Addendum No. 1

Contract No.: DA00169

WBS No.: 42999.3.1

*Drainage, Grading and Paving to improve curve radius on SR 1227 (South Mills Rd.),
Currituck County*

REVISED: 9-26-2013

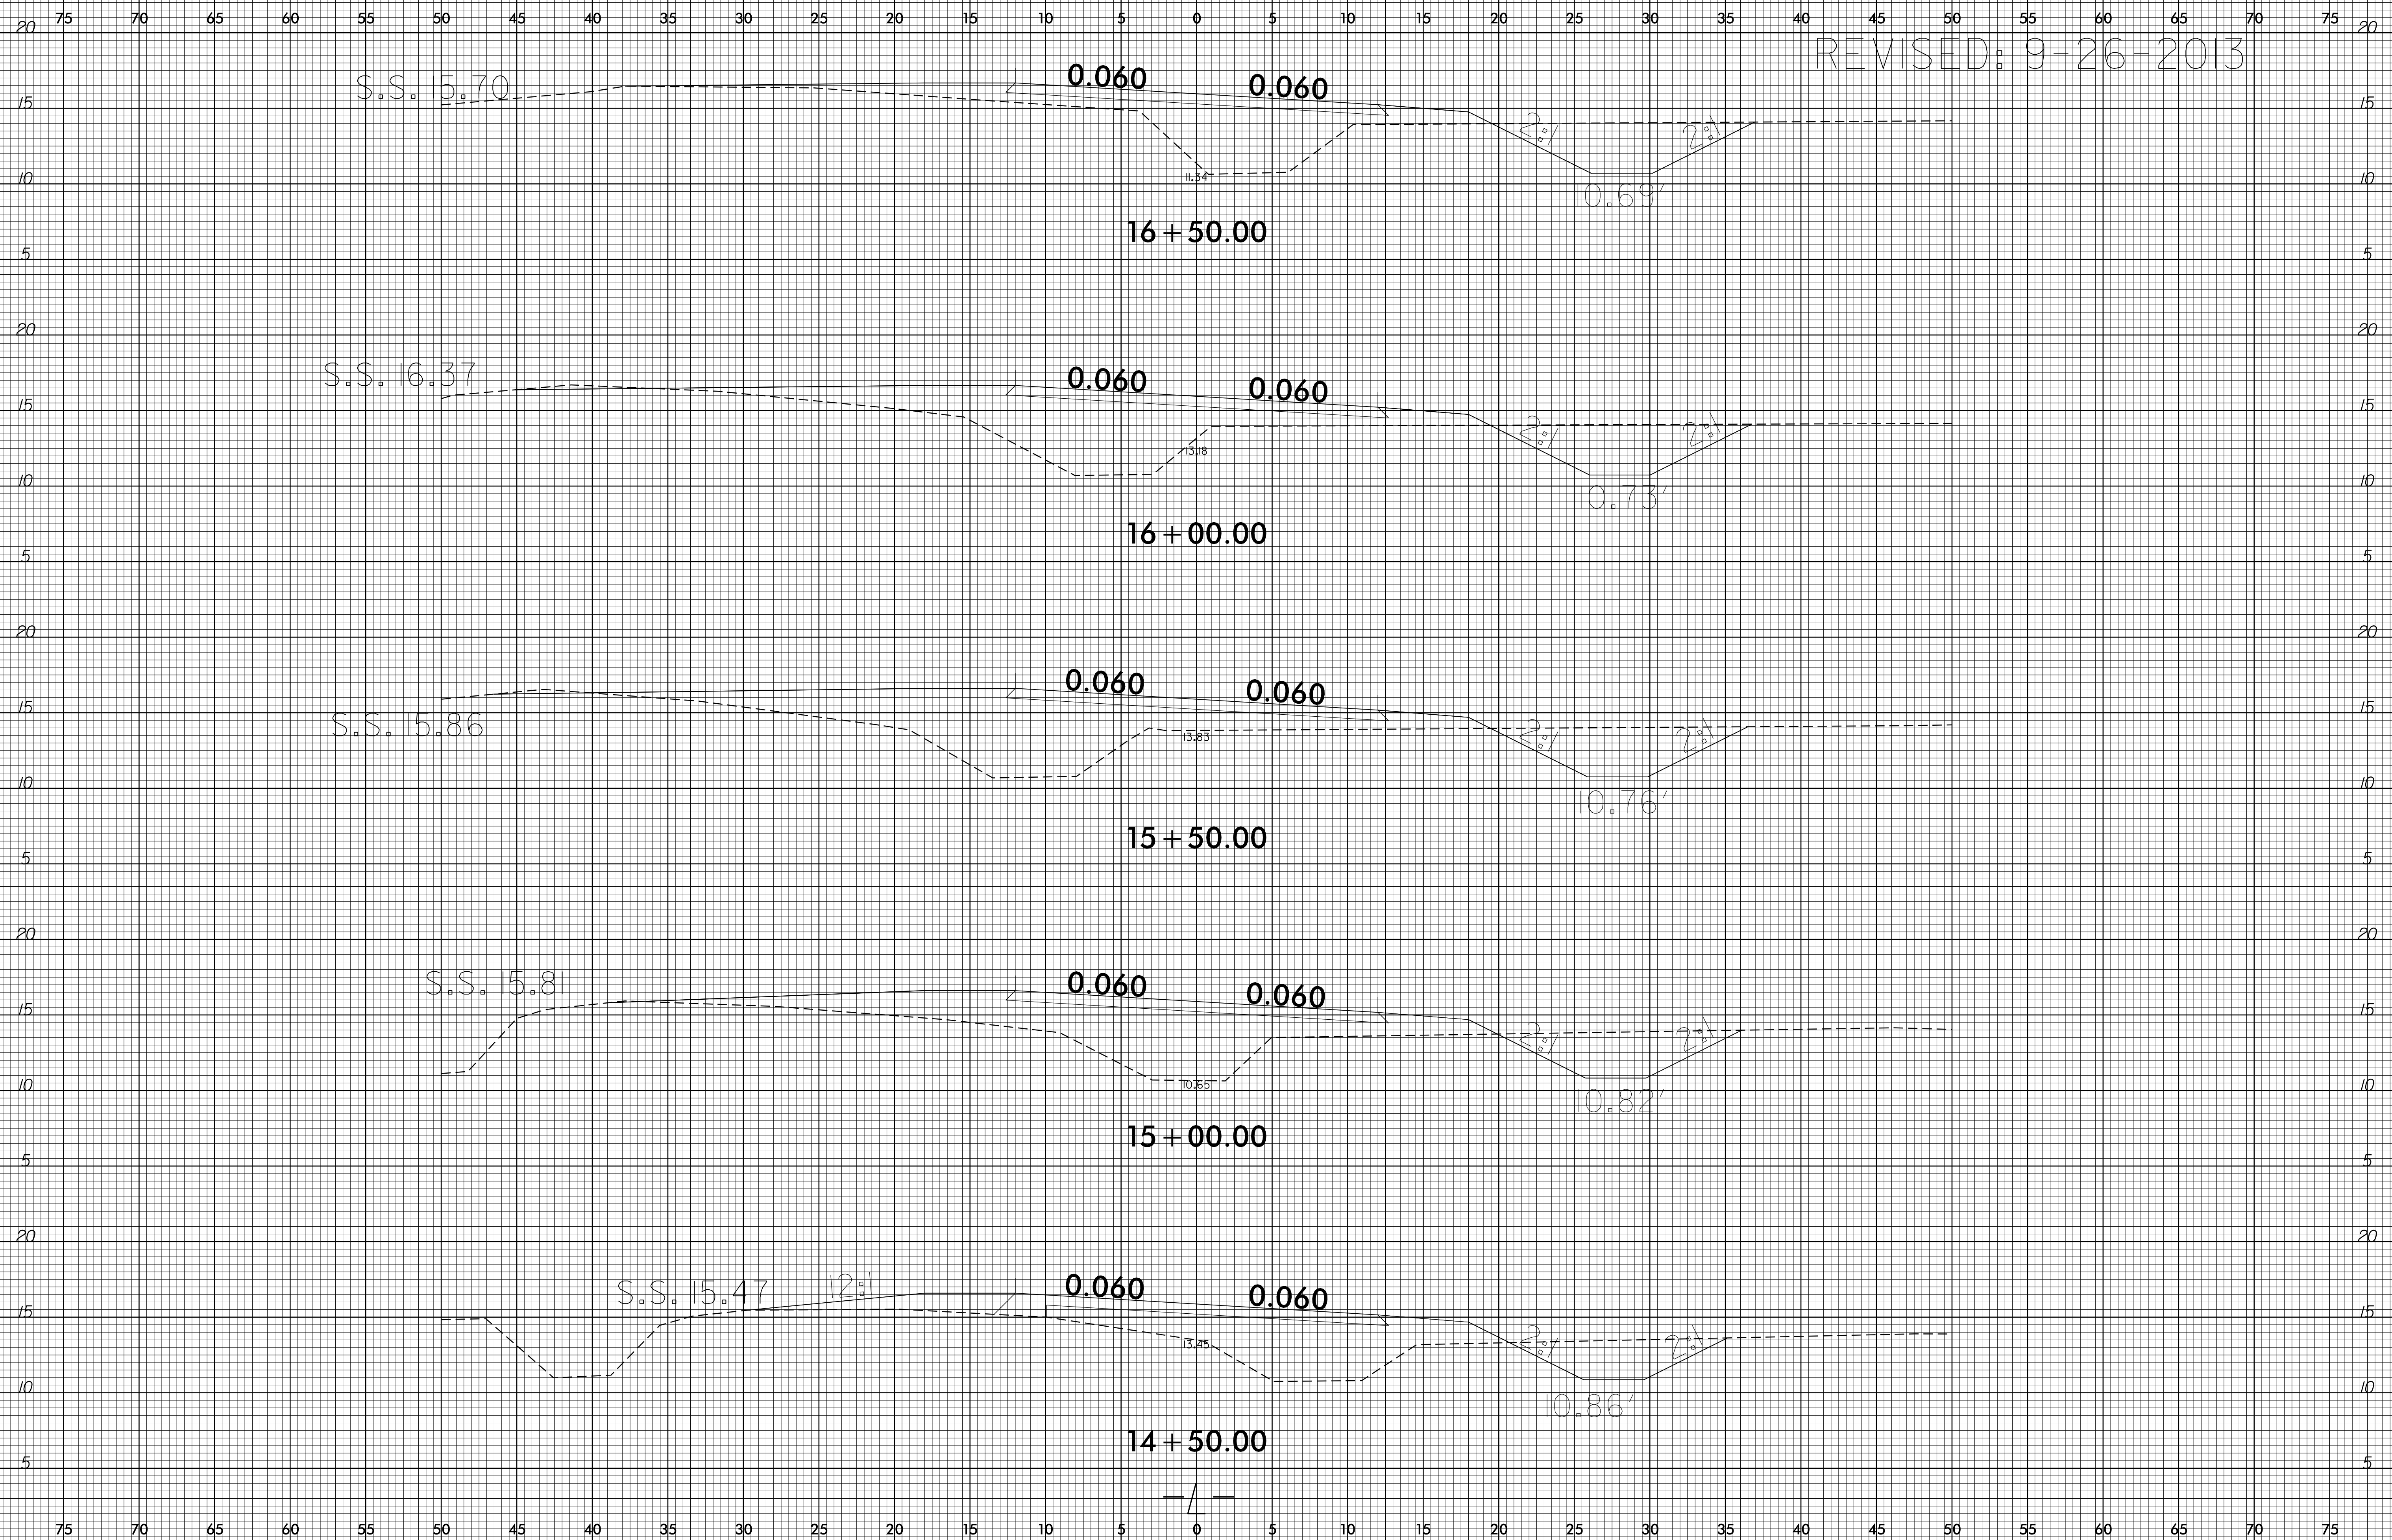
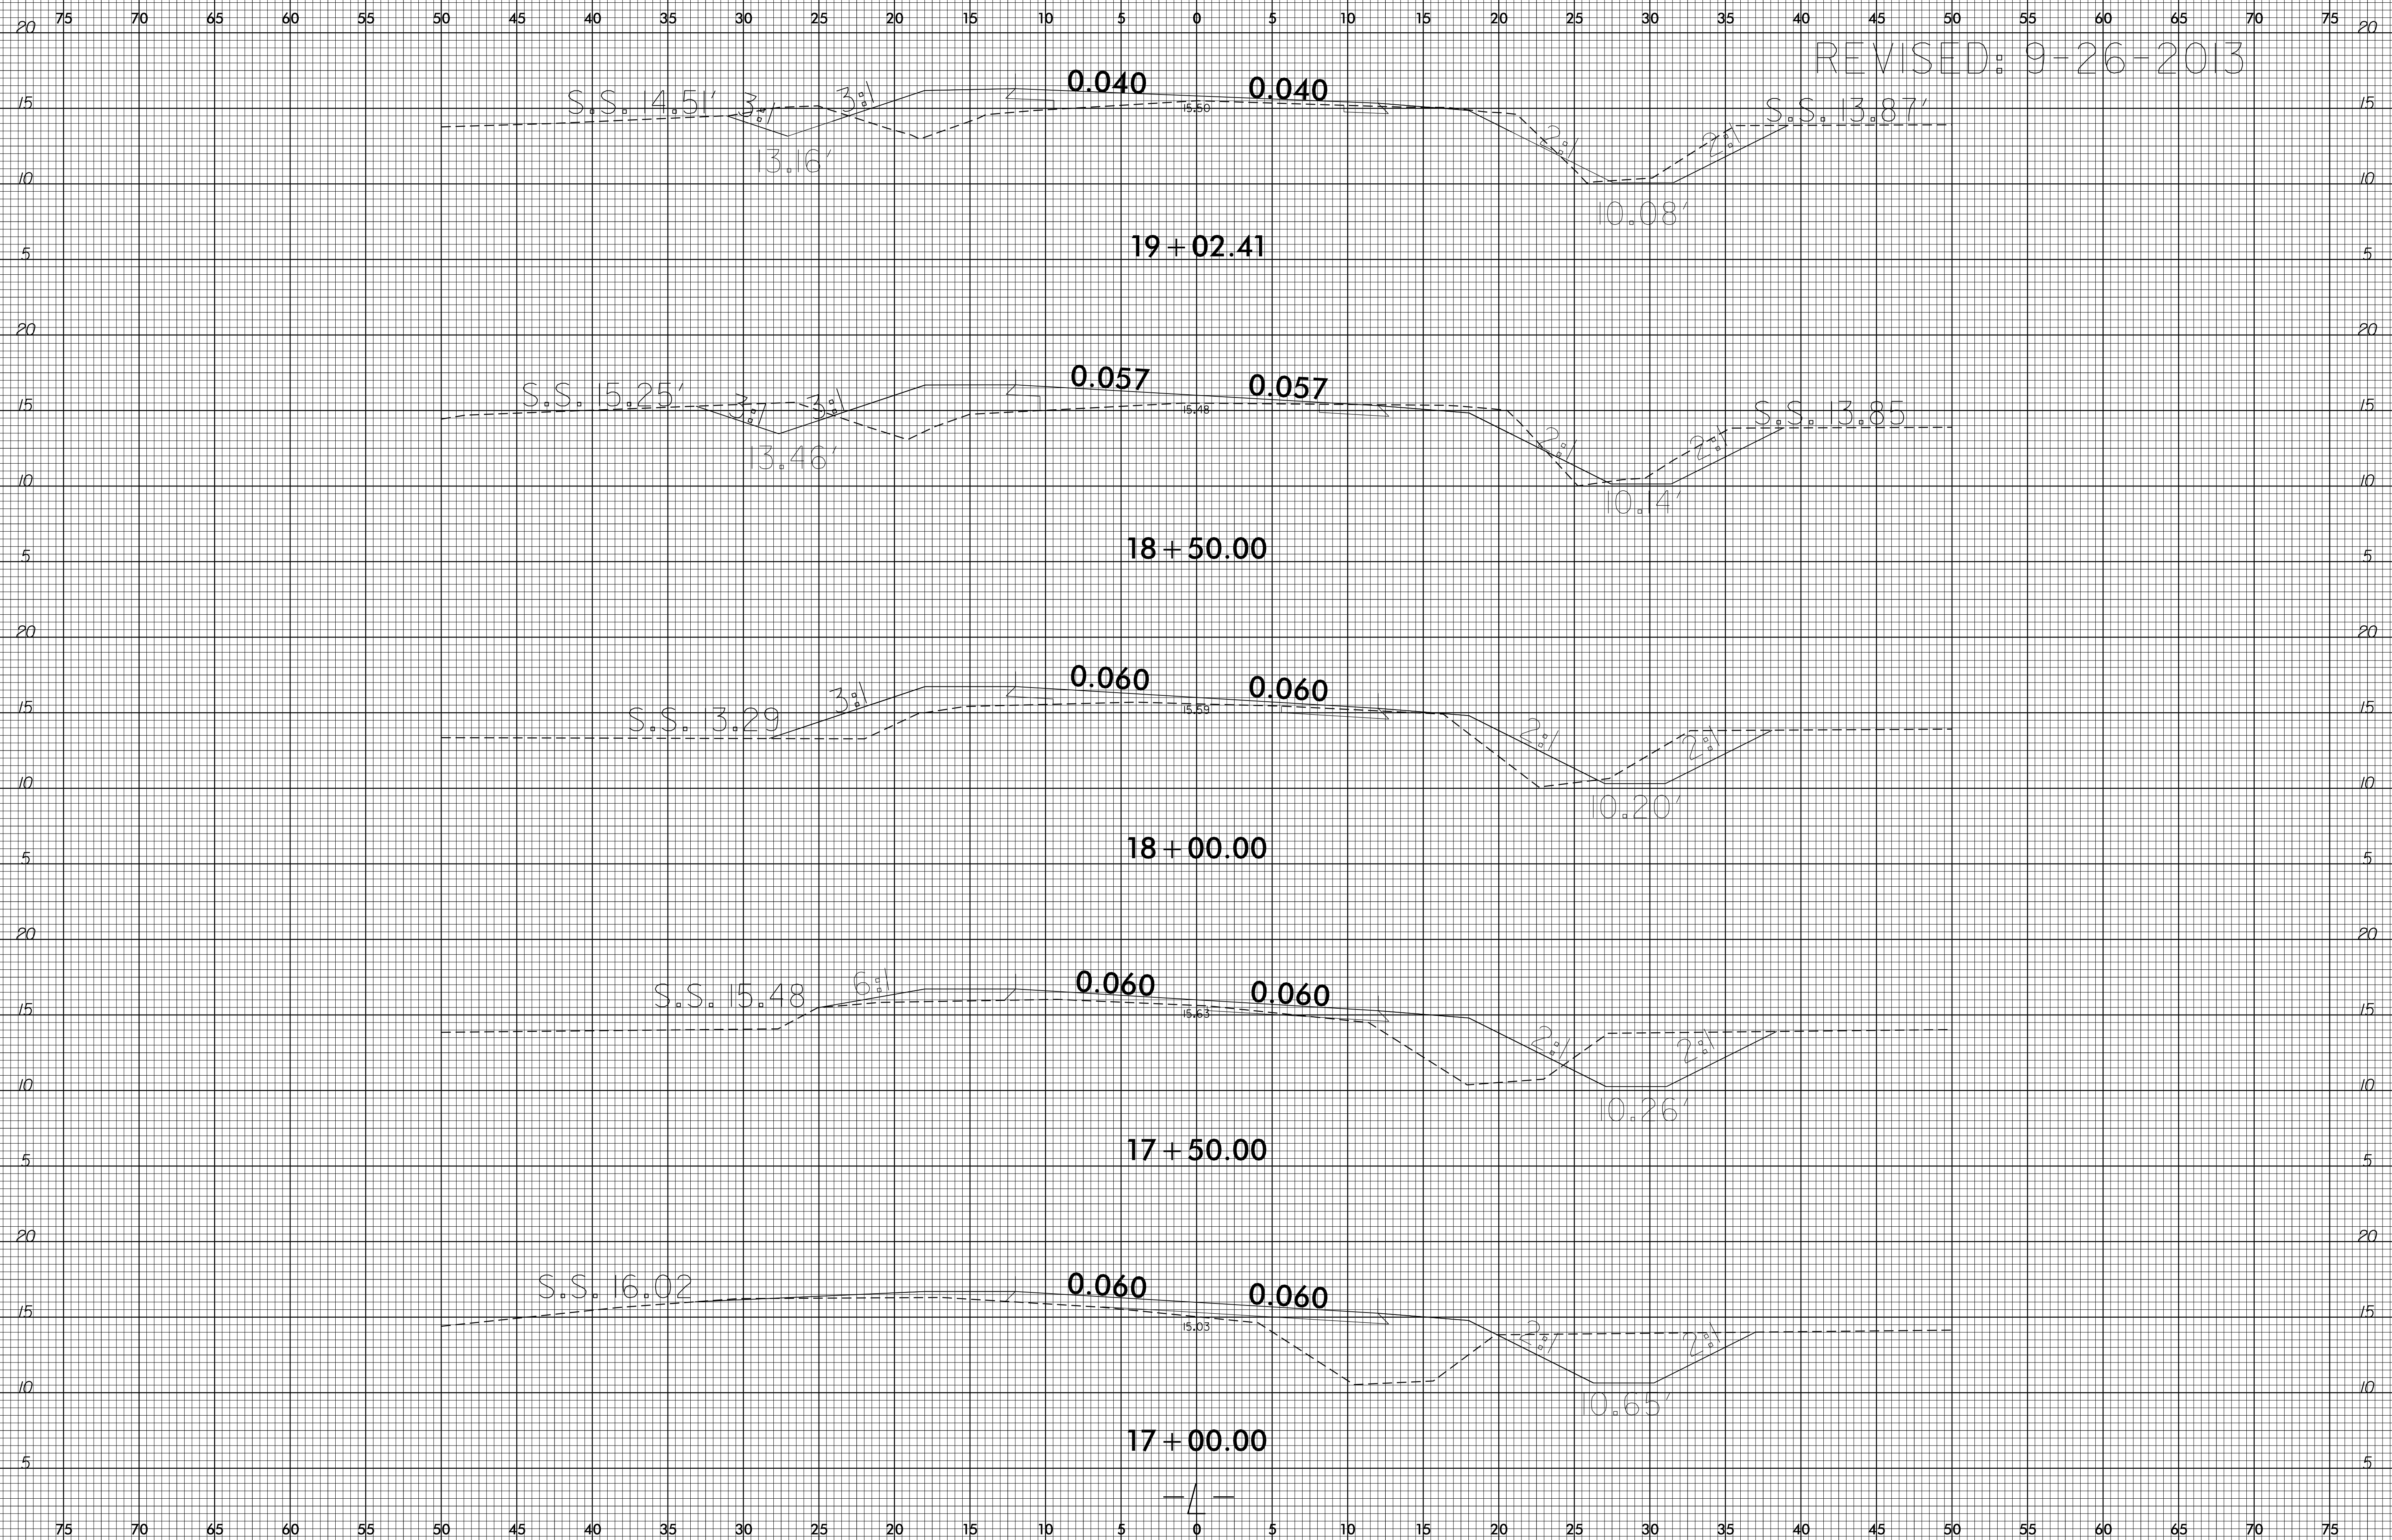
Plan Sheets X-1 to X-5 have been updated to illustrate the revised centerline profile." Please void the existing Plan Sheets X-1 to X-5, in the proposal and staple revised Plan Sheets X-1 to X-5 thereto and acknowledge addendum on the Bid Form.
